TRANS/WP.29/GRE/2005/44 25 July 2005

PROPOSAL FOR DRAFT 03 SERIES OF AMENDMENTS TO REGULATION No. 48

(Installation of lighting and light-signalling devices)

Transmitted by the Chairman of the Conspicuity Marking Informal Working Group

Model B

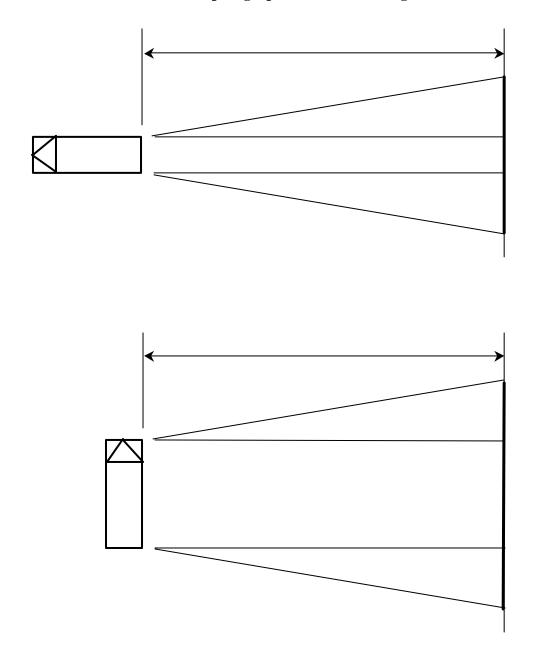
The above approval mark affixed to a vehicle shows that the vehicle type concerned has been approved in the Netherlands (E4) pursuant to Regulation No. 48 as amended by the **03** series of amendments and Regulation No. 33. 1/ The approval number indicates that, at the dates when the respective approvals were given, Regulation No. 48 was amended by the **03** series of amendments and Regulation No. 33 was still in its original form."
